## AMENDMENT OF SOLICITATION/CONTRACT (AGREEMENT)

## QUESTIONS AND ANSWERS

PROJECT: **ACTIVATE:  
SHOPPETTE IMAGE  
UPGRADE**

BLDG #2204  
**FORT BELVOIR, VA**

DATE:	19 AUG 2009
AAFES Project Number:	0307-09-00009
SCALE:	As Indicated
PROJECT NUMBER:	0007
	<b>PE-101</b>

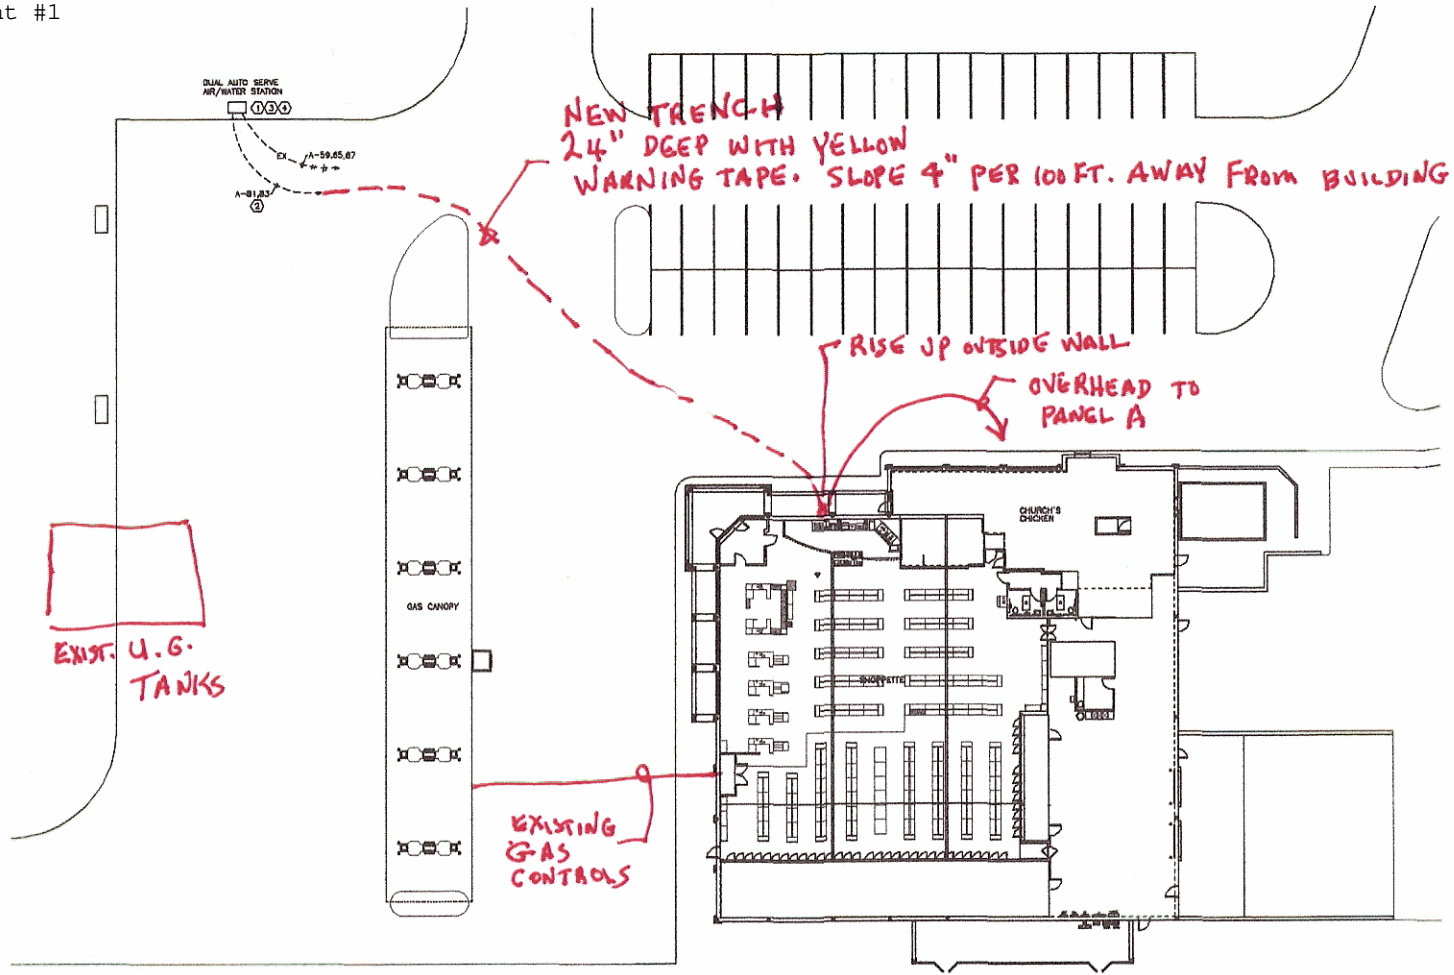
QUESTION 5: Amendment #1, Question and Answer #1 indicates requirement to install two (2) 20A/1P Circuit Breakers in existing Panel A for circuits 81 and 83. The drawings do not call for any neutral wires. Please confirm the circuit breaker should be a 20/2P?

QUESTION 7: We have received your pre-bid response to Attachment #1 of Amendment #1. Please clarify the routing as there are arrays of gas tanks between the new dual auto serve air/water station and Panel A within the existing building. As shown on PE-101, circuit A-81, 83 please clarify distances to Panel A (as scaling the plans is not a good idea), and whether trenching will be required and patching is required of the asphalt or concrete? Is there an existing underground conduit so that excavating and trenching will not be required? If so, how deep of a trench do electricians need to dig? :

ANSWER 5: Two 20/1 P CB's are required to be added to Panel A. The Circuit should be 3 #8 & 1 #10 (G) – 1”C, 2 Phase legs, 1 neutral and 1 grounding conductor.

ANSWER 7: See inclosed drawing, PE-101 (Inclosure #1 consisting of 1 page), revision dated 29 Sep 09?

- KEYNOTES: PLUMBING AND ELECTRICAL SITE PLAN
- ① DISCONNECT CIRCUIT TO SINGLE AUTO AIR/WATER STATION AND RETAIN FOR REUSE EXISTING STATION TO BE REPLACED WITH A DUAL AUTO AIR/WATER STATION.
  - ② 2#8 & 1#10(0)-3/4" TO PANEL A.
  - ③ DISCONNECT WATER FROM EXISTING AIR/WATER STATION REMOVE PIPING DOWNSTREAM OF SHUT-OFF VALVE.
  - ④ RECONNECT NEW DUAL AIR/WATER STATION WITH 3/4" CW PIPE.
